DESIGN REVIEW BOARD JANUARY 21, 2022

Design Review Board Meeting
November 19, 2021
Department of Community Development
ALPHARETTA CITY HALL | 2 PARK PLAZA
8:30 AM

STUDIO ADDITION
BALCONY ELEVATION

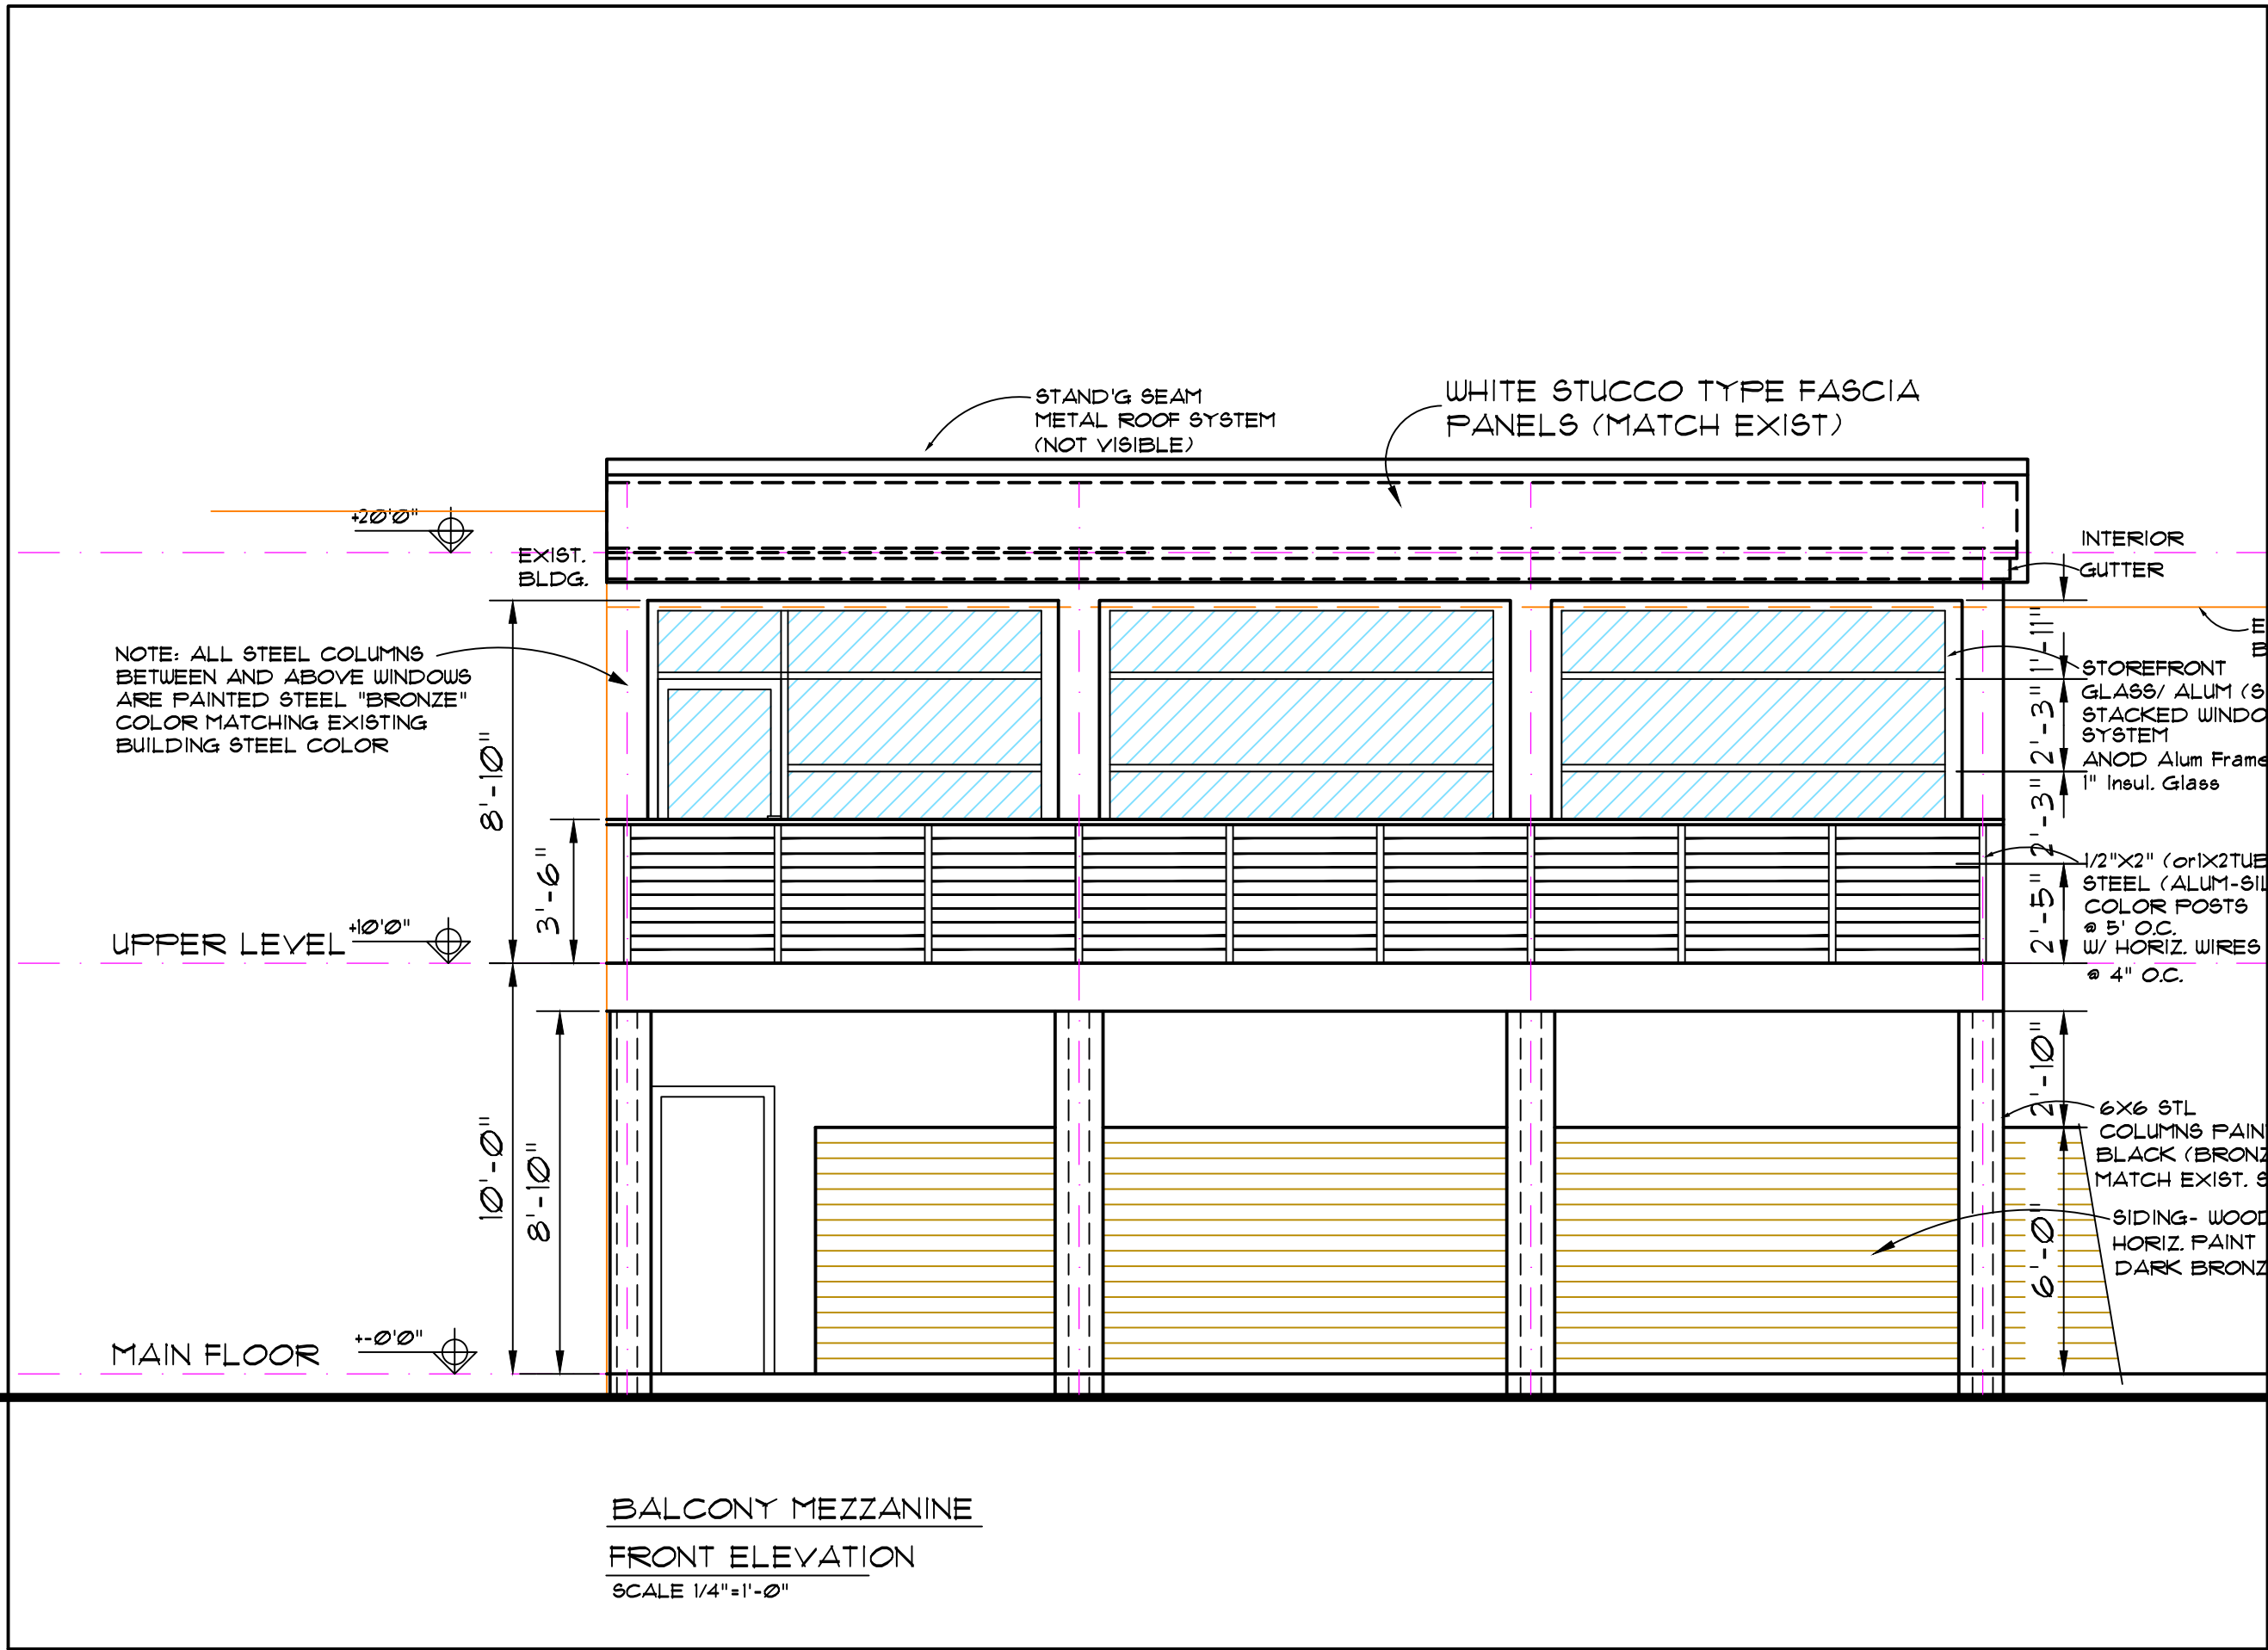
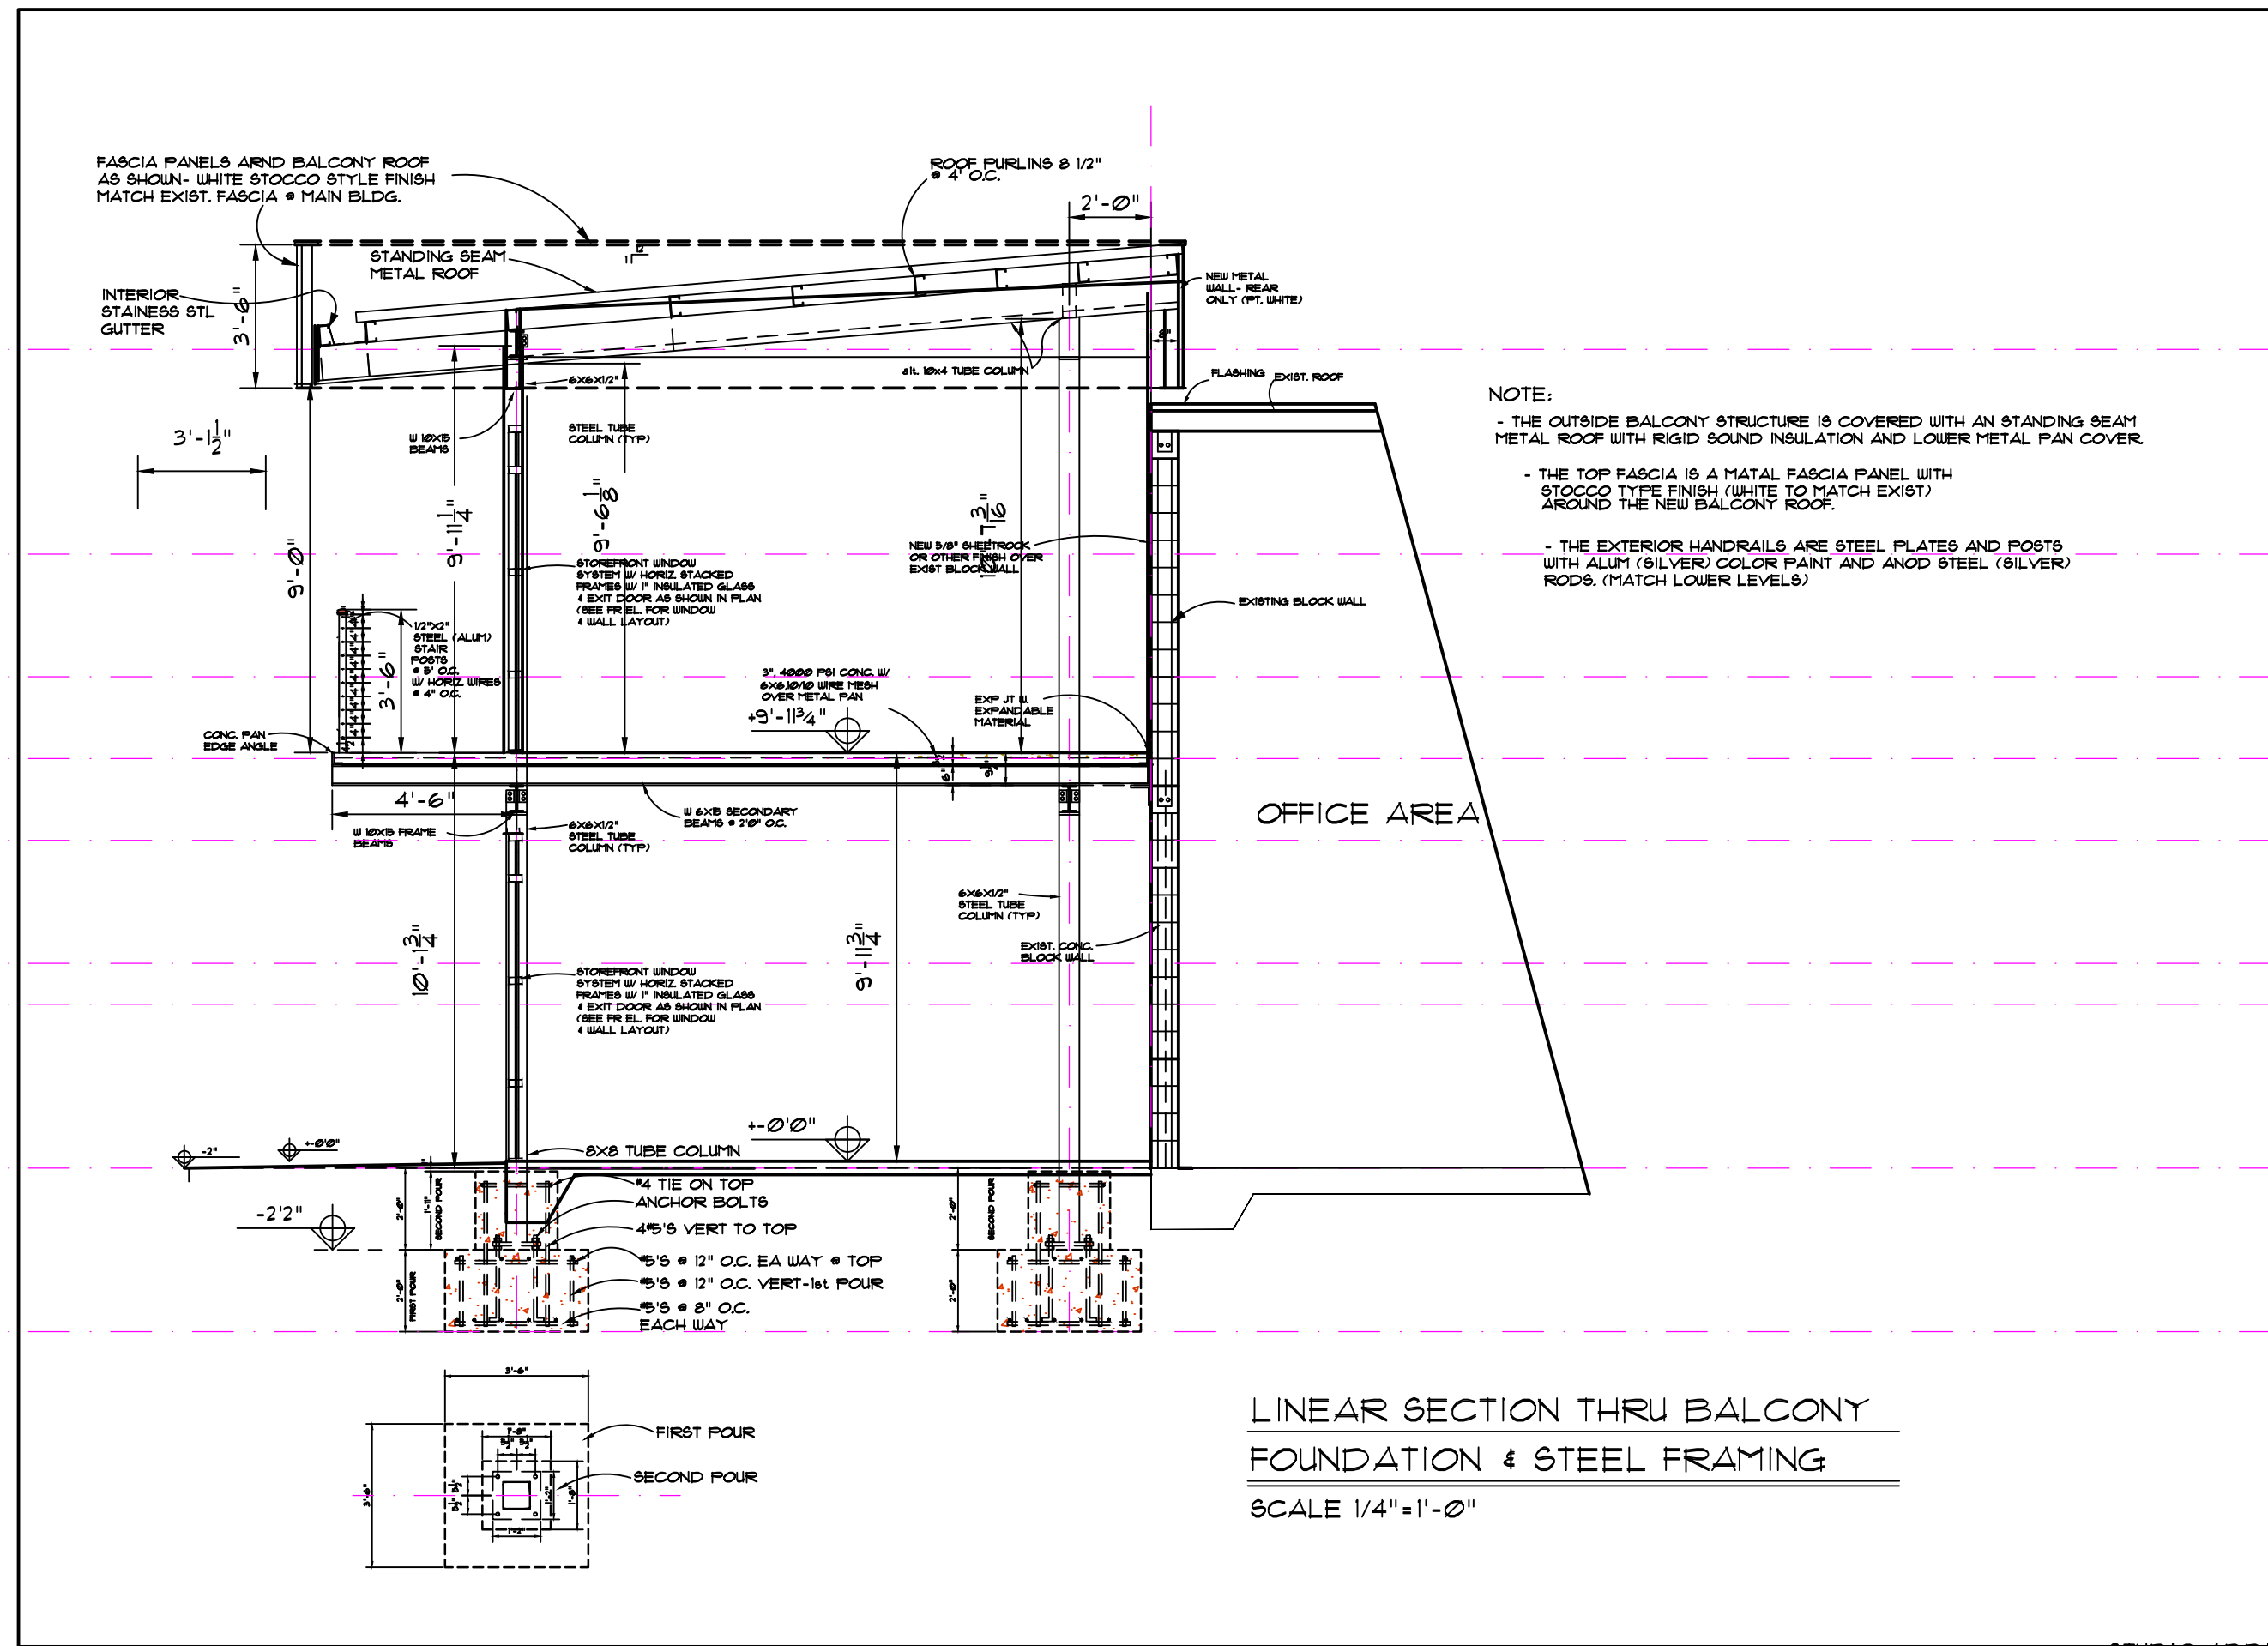
As per your comments we have added a new fascia around the balcony roof with the finish matching the existing building fascia. We have modified the lower level back to the existing conditions keeping the air conditioning units and the fence around (with new finish and Bronze paint). We are painting the frame a bronze color matching the existing frames as shown in the pictures. The windows and handrails are aluminum color matching existing storefronts.
